Date: May 10, 2013

This Addendum varies the Bidding and Contract Documents published for Tender on the MERX System on April 29, 2013.

Base Building Retrofit and Fit-Up
 Harry Stevens Building, Vancouver, B.C.
 Project No. R.052411.001

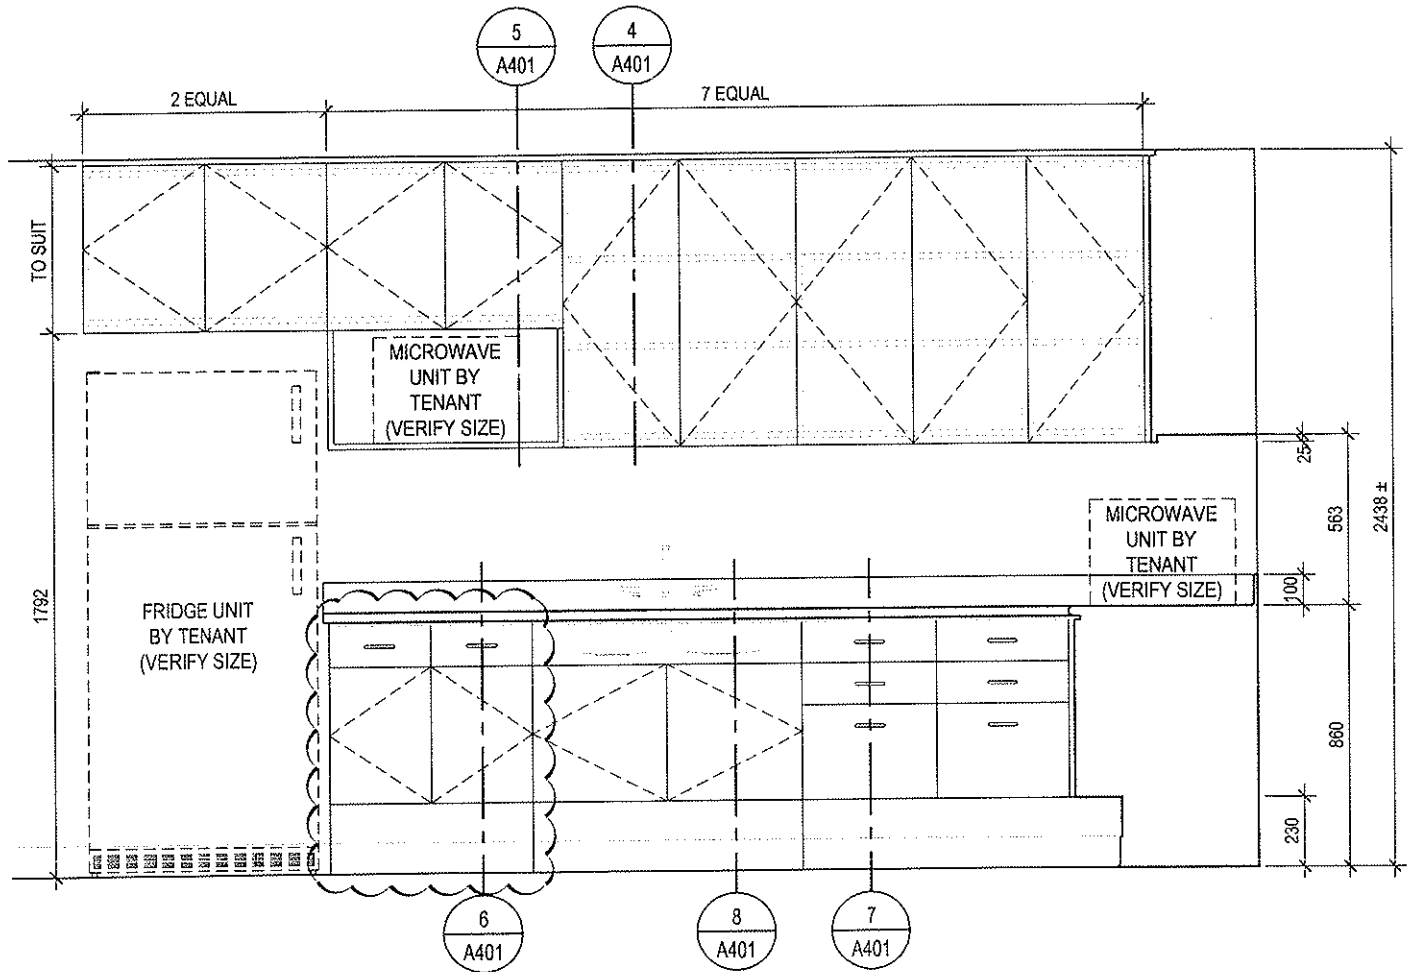
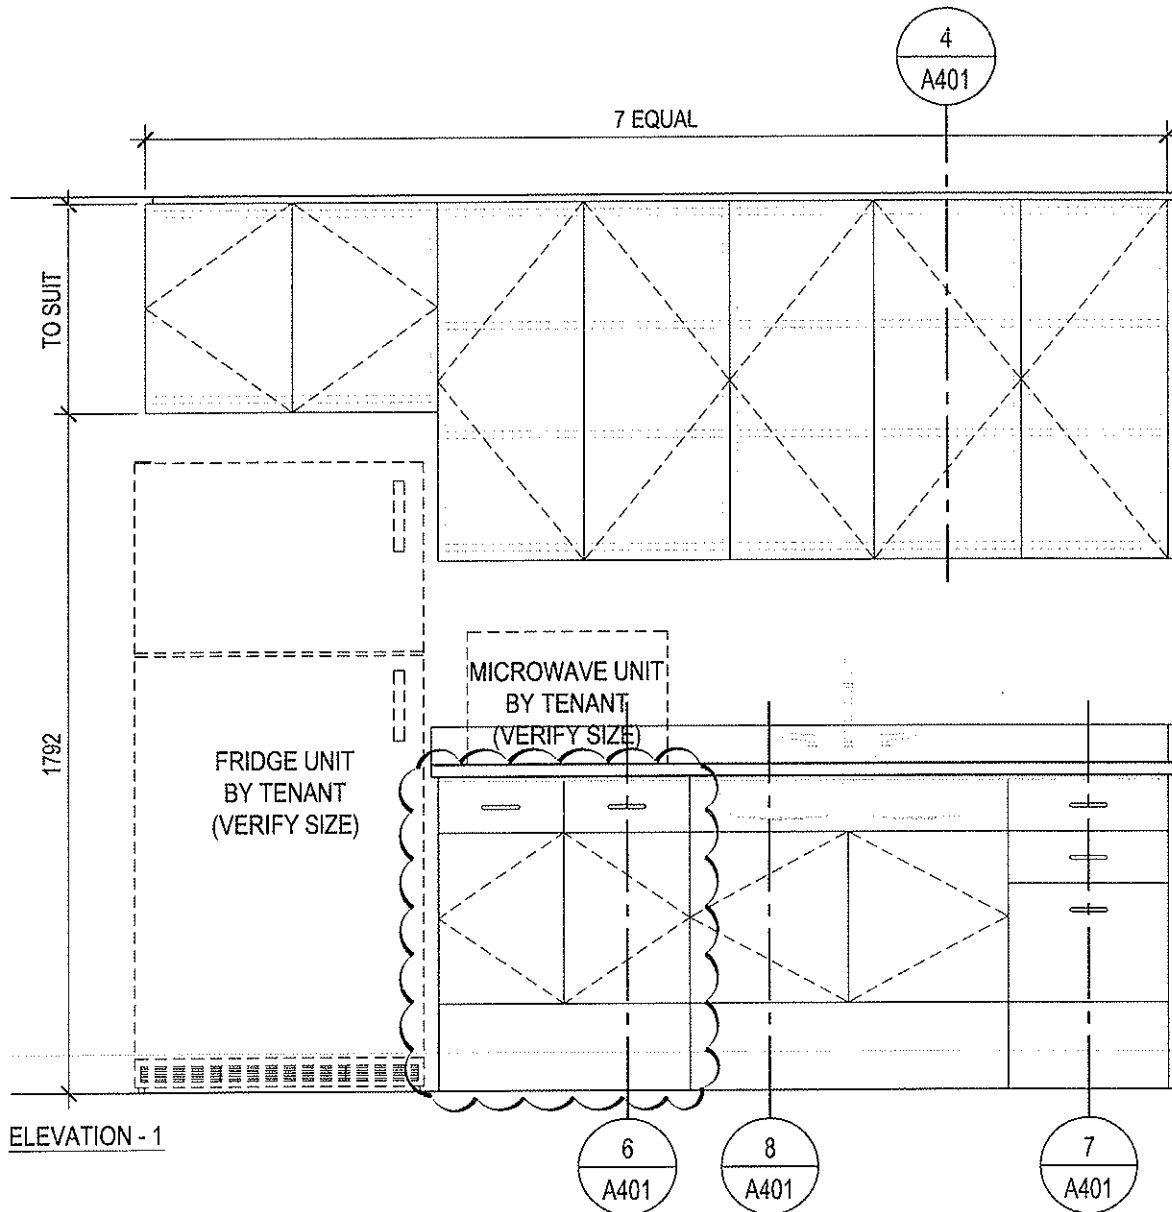
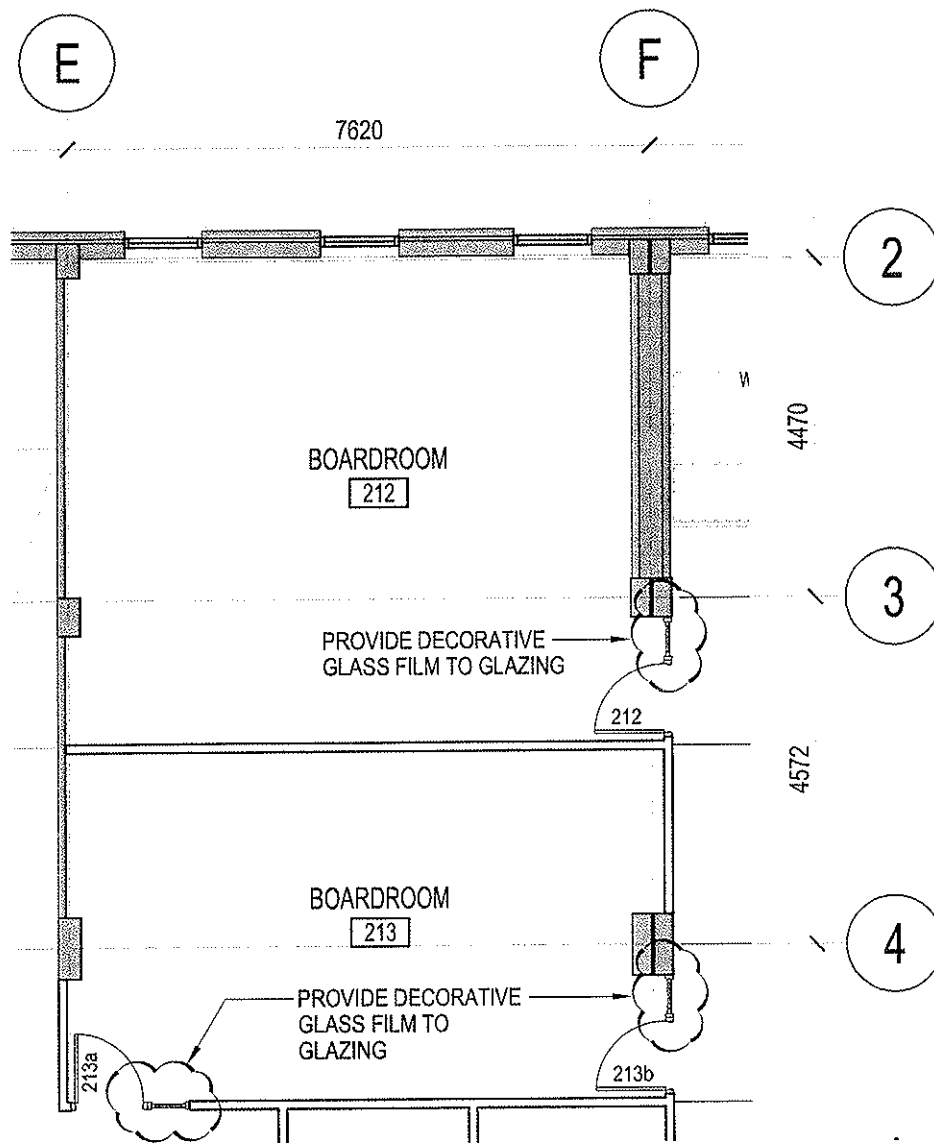
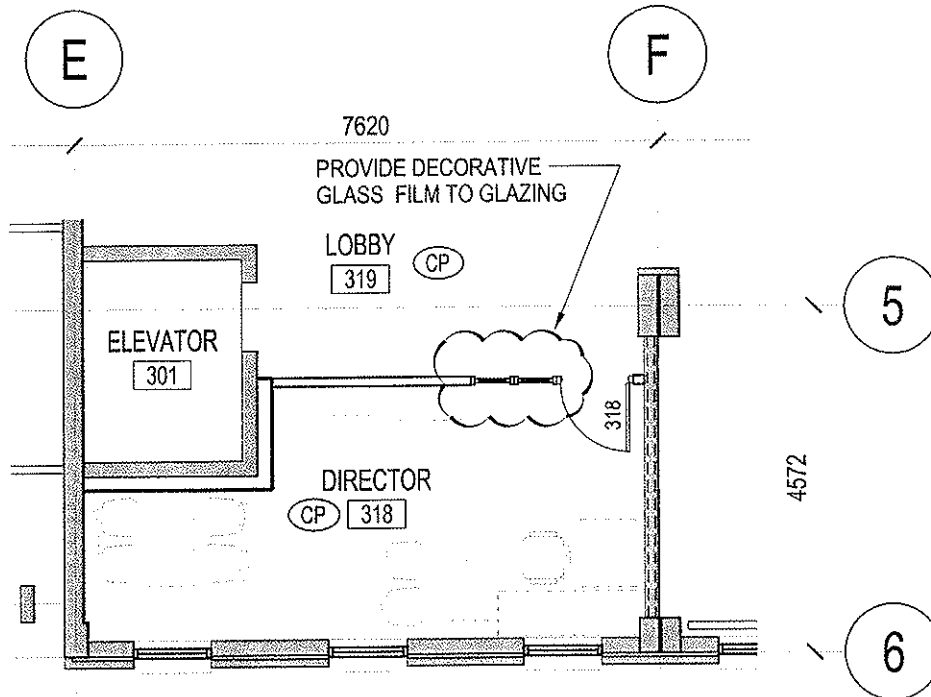
2.3 Reference Drawing A401

Revise: Refer to attached **Sketches ASK-1, ASK-02, ASK-03**

ASK-05

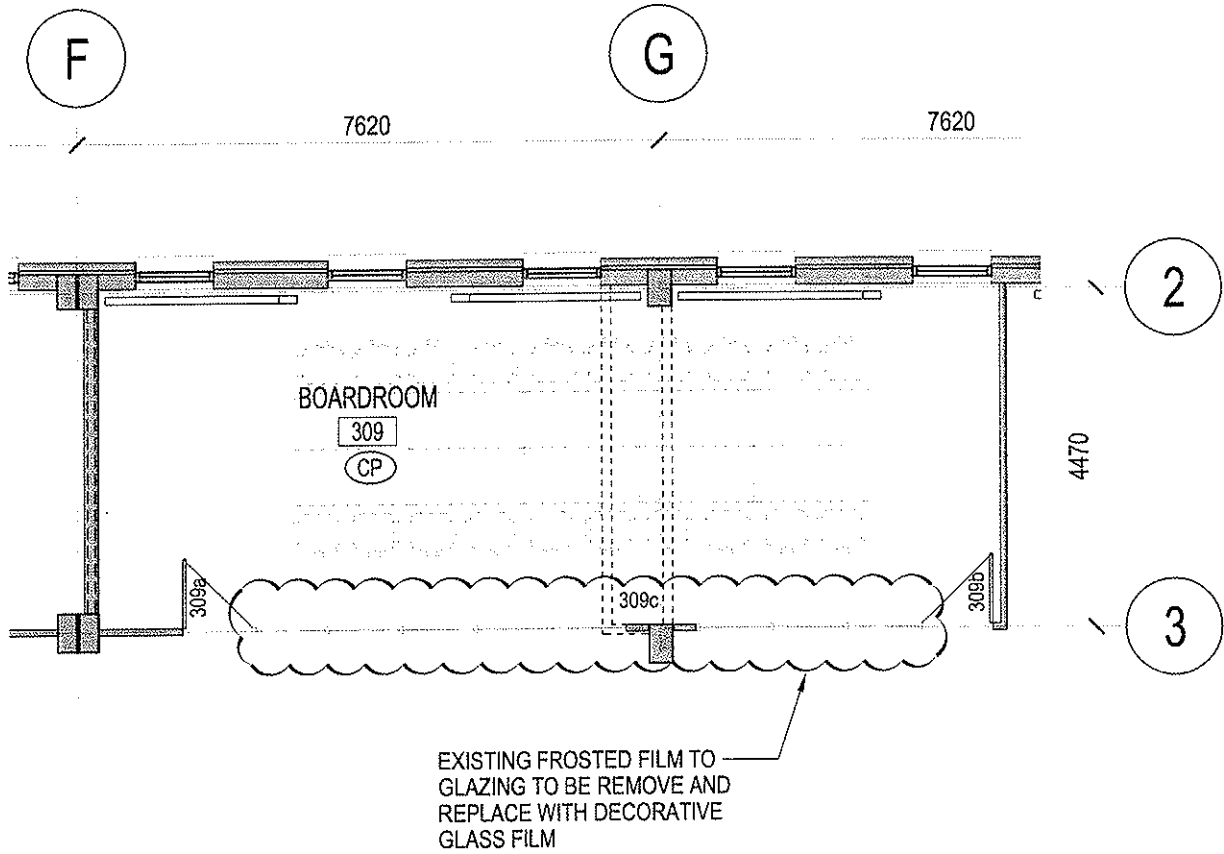
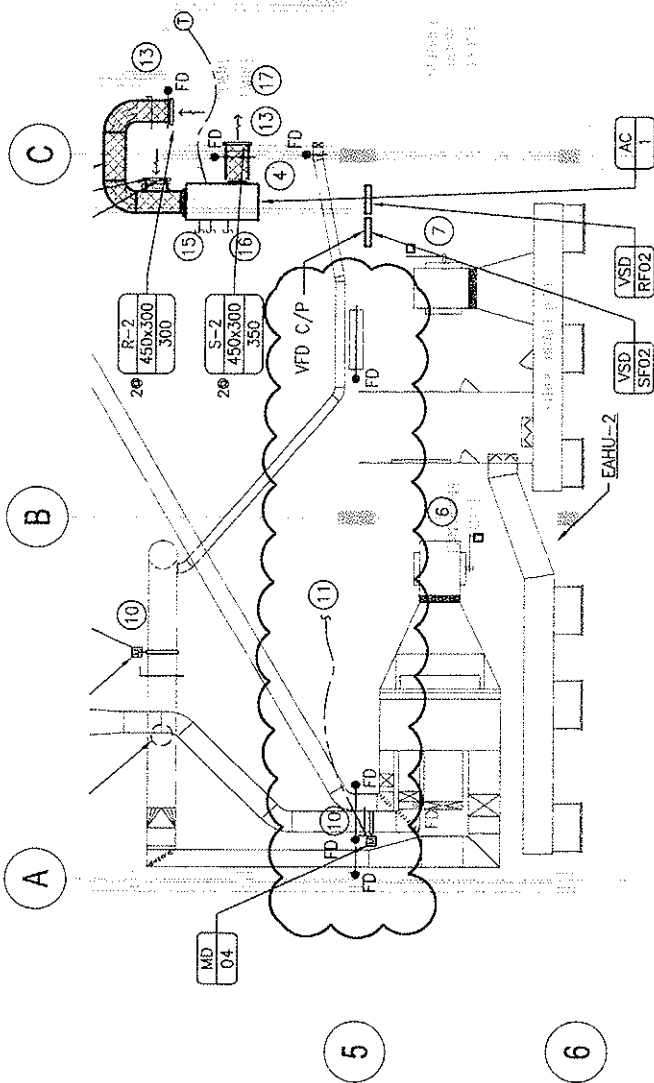
2.2 Reference Drawing A203

Revise: Refer to attached **Sketch ASK-05**

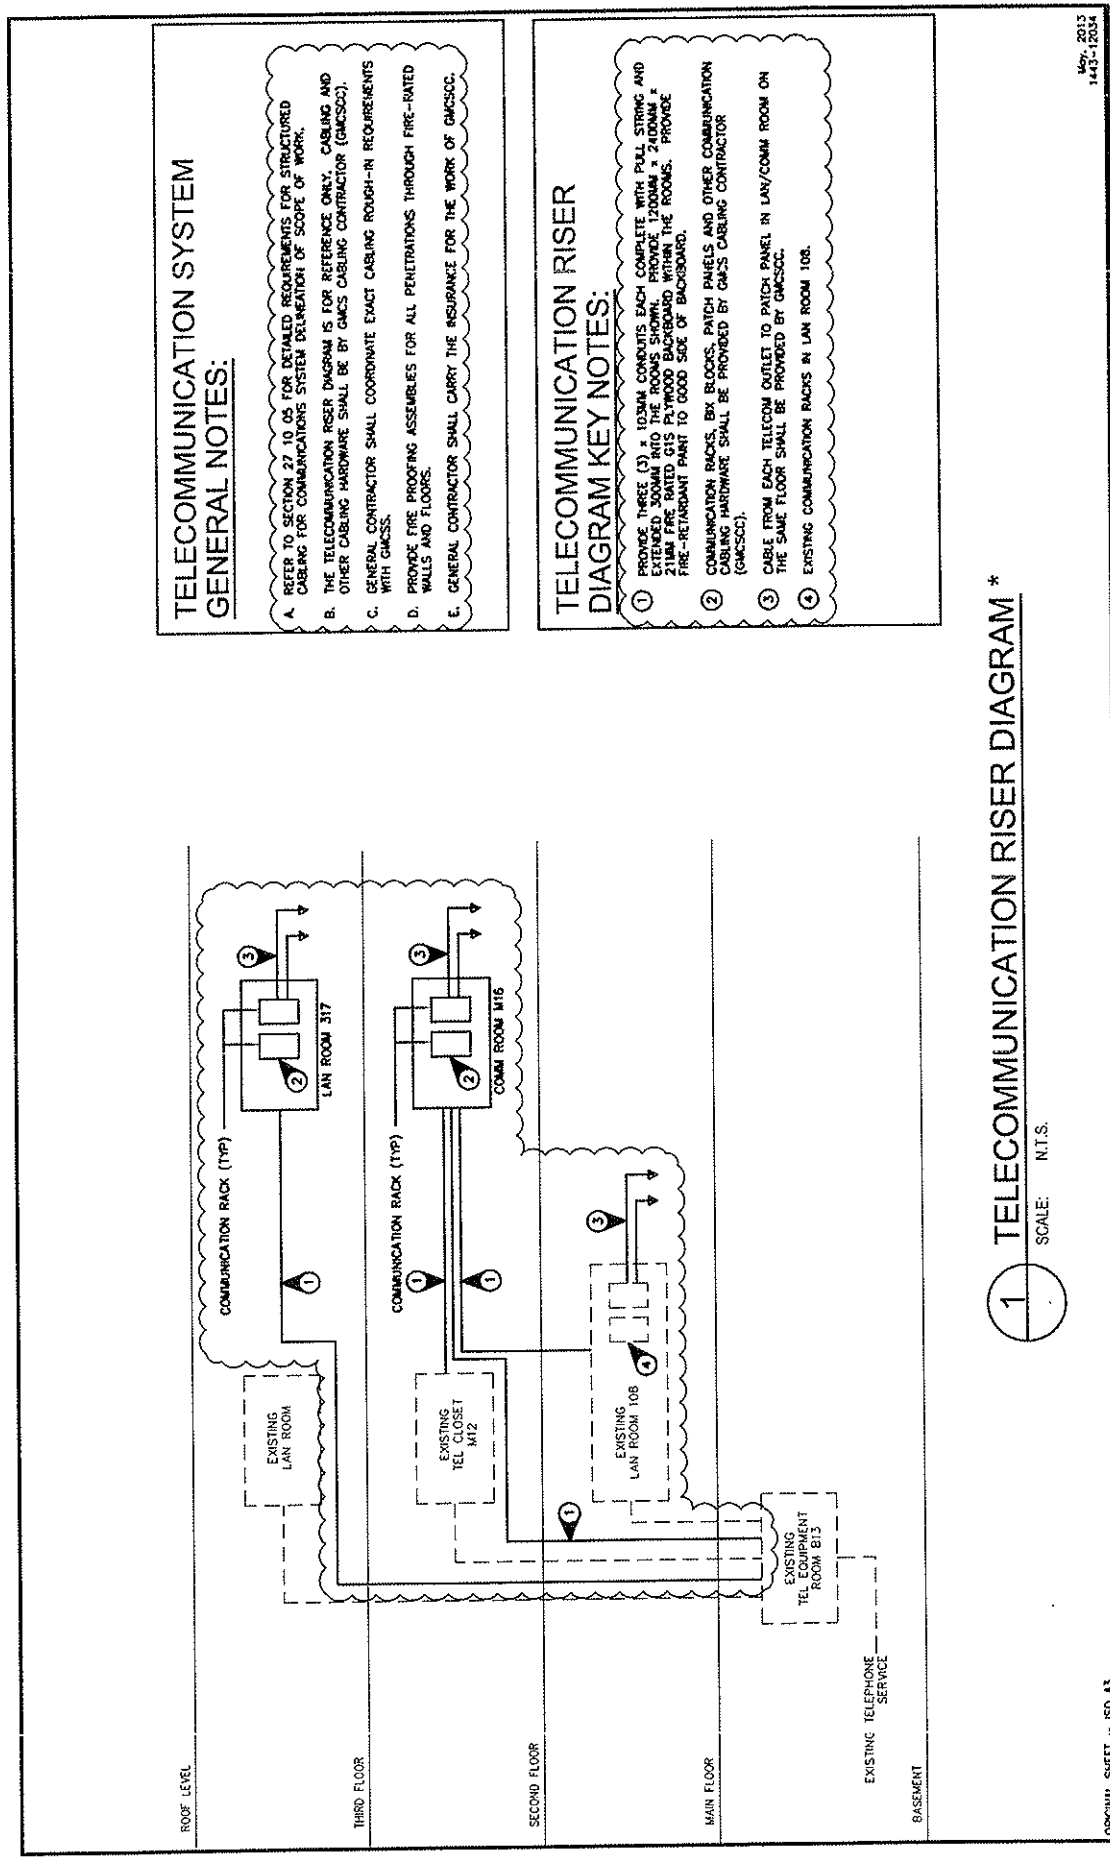
2.7 Reference Drawing M202

Add: General Notes 9 and 10 regarding the branch duct size and fire dampers as pre attached sketches **Add-M01-MSK01**.

Add: Fire dampers on the all duct penetration through the fire rated partition wall of mezzanine mechanical along the gridline 5 as pre attached sketches **Add-M01-MSK01**.

Add: Fire dampers on the all duct penetration through the fire rated partition wall of kitchen room M07 as pre attached sketches **Add-M01-MSK02**.

8. ASBESTOS WILL BE REMOVED BY OTHERS. SEE ARCH. DRAWING FOR DETAIL.
9. THE BRANCH DUCT SIZE SHALL BE THE SAME AS THE NECK SIZE OF EACH CONNECTED DIFFUSER, UNLESS OTHERWISE NOTED.
10. PROVIDE FIRE DAMPERS AT ALL EXISTING AND NEW DUCT PENETRATION THROUGH FIRE RATED WALLS AND FLOORS.
